Final Author Reply to the Editor

Caleb Akhtar Martínez, Sebastian D. Eastham, and Jerome P. Jarrett

Responses to Anonymous Referee #1

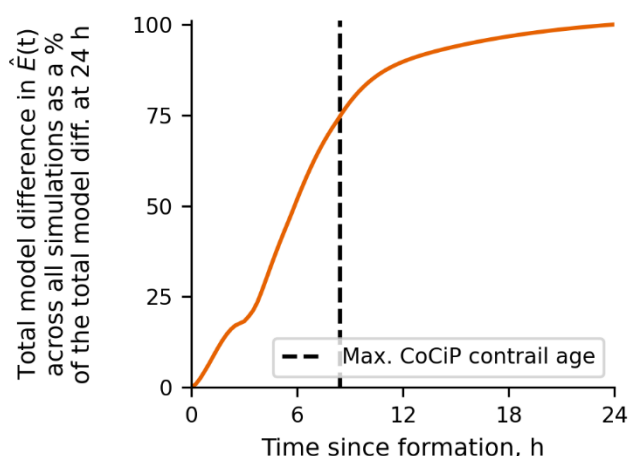
Author’s response:

- Fallstreak sub-regime -> unrestrained sub-regime
 - We believe that the word “unrestrained” accurately reflects the fast vertical separation of the precipitation plume from the contrail core.
- Settling sub-regime -> restrained sub-regime

- The contrail now spreads in a slower manner and primarily in a horizontal direction, so we believe that “restrained” is more appropriate than “settling”.
- Fading sub-regime -> unchanged

Furthermore, we have replaced the reference to “fallstreak” in the title with “Zero-Dimensional model” to avoid confusion.

Author’s changes in manuscript: Changed the sub-regime names in the manuscript text and figures as required. Also changed the title from “Contrail models lacking post-fallstreak behavior could underpredict lifetime optical depth” to “Zero-dimensional contrail models could underpredict lifetime optical depth”

For the following analysis we reproduce part of the curve corresponding to 5 μm from Fig. 4a) of Wolf et al. (2023):

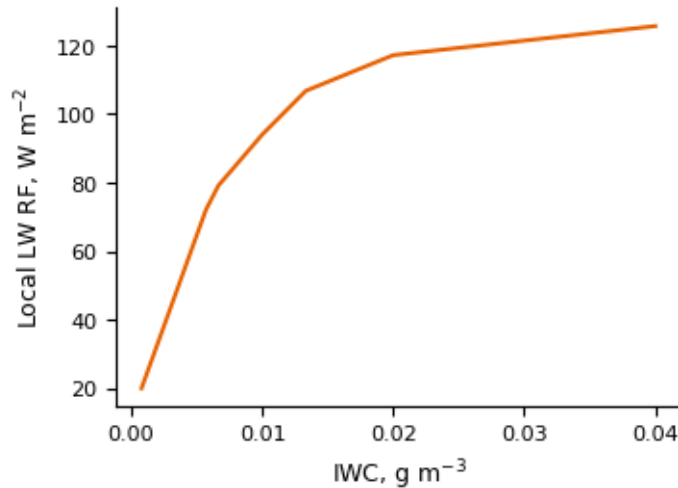
“Line 39: Can you substantiate the statement about thin contrails having the largest cloud radiative effect (what you call local RF)? Unterstrasser & Gierens (2010) and Lewellen (2014) show at least the dependence on wind shear.”

Author's response: We appreciate that we have been vague in this explanation, and we welcome the suggestion to substantiate the point. Please find here an explanation of what we mean:

Consider two contrail segments under the same ambient conditions with the same ice mass per unit contrail length of 20 kg m^{-1} , with both contrails having the same depth of 500 m. Assuming that contrail A is 1 km wide, and that contrail B is 2 km wide, the ice water content (IWC) of contrail A (0.04 g m^{-3}) is two times the IWC of contrail B (0.02 g m^{-3}). Fig. 4b) of Wolf et al. (2023) shows that contrail A will have an instantaneous longwave radiative forcing (LW RF) of $\sim 125 \text{ W m}^{-2}$, while contrail B will have an instantaneous LW of $\sim 115 \text{ W m}^{-2}$. Accounting for the contrail width, contrail A will have a LW RF of $\sim 125 \text{ W m}^{-1}$, whereas contrail B will have a LW RF of $\sim 230 \text{ W m}^{-1}$. Contrail A, the one with higher optical depth (due to its higher IWC), will have a lower energy forcing than the more dilute but wider contrail B. This implies that, for the same total ice mass, contrails that have a large horizontal span but are optically thin may have a greater climate impact than thicker, narrower contrails.

Author's changes in manuscript: Created a new Appendix "G" with the above explanation. In line 41 of the updated manuscript, we replaced:

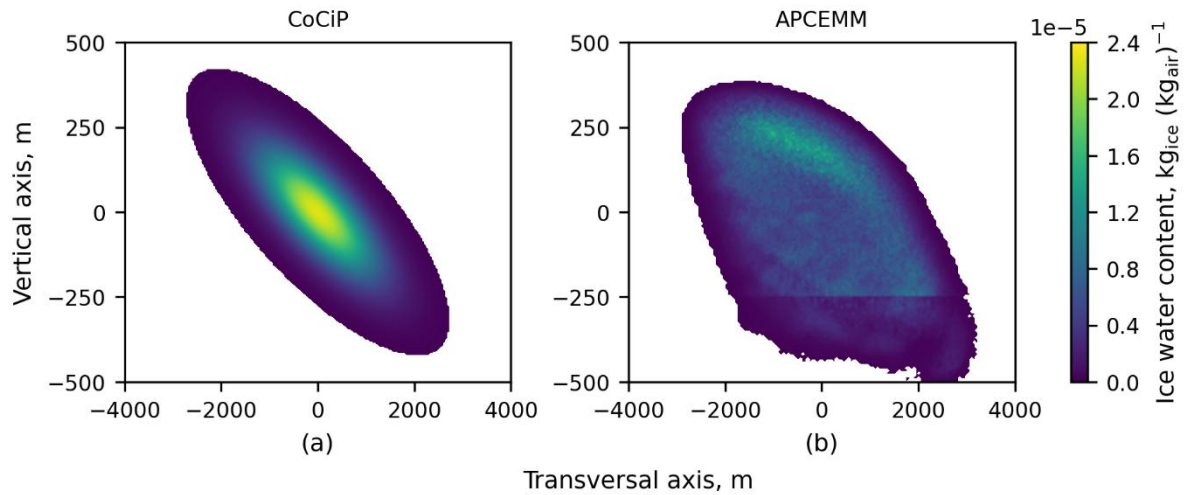
The change in the slope of the ice crystal number reduction might be a particular result of APCEMM and the idealized scenario used. In reality, vertical motions in the atmosphere will perturb the contrail evolution.”

Author’s response: This comment raises two points. First, it suggests that we should focus on the contrail simulations up to 10 hours due to how uncommon contrails lasting beyond this are. To consider this suggestion in a fair manner, we have produced an additional figure showing the sum across all unique simulations of the difference in time-integrated total extinction between the models. For ease of interpretation, this has been normalized with the total difference (summed across all simulations) at 24 hours. Each time on the x axis serves as the upper limit of integration, hence the variation with time.

After much consideration, we have decided to not shift the focus of the analysis to the first 10 hours. This is because, according to the figure above, 90 % of the model difference in the time-integrated total extinction is produced within 12 hours from formation. Hence, our conclusions still hold even if contrails that persist for longer 12 hours are rare. Nevertheless, we are grateful

Author's changes in manuscript: Included the above figure and explanation in a new section: Section 4.1.3:

Figure 10 shows how $\hat{\delta}(t)$ varies as a function of time. We hence find that 90 % of the global model difference is produced within 12 hours from formation. For more evidence-based contrail lifetime estimates, we take 4 h and 8 h from a recent preprint by Hofer and Gierens (2025). The proportion of the total model difference reached by 4 h and 8 h are 27 % and 72 % respectively. These results indicate a large sensitivity in our findings to the lifetime of typical contrails. However, they also indicate that our findings are particularly relevant to those 6–7 % of contrails that persist beyond 8 h (Gierens and Vazquez-Navarro, 2018). Such contrails are also likely to be the greatest contributors to aviation warming on an individual basis, and are hence important for contrail avoidance.”
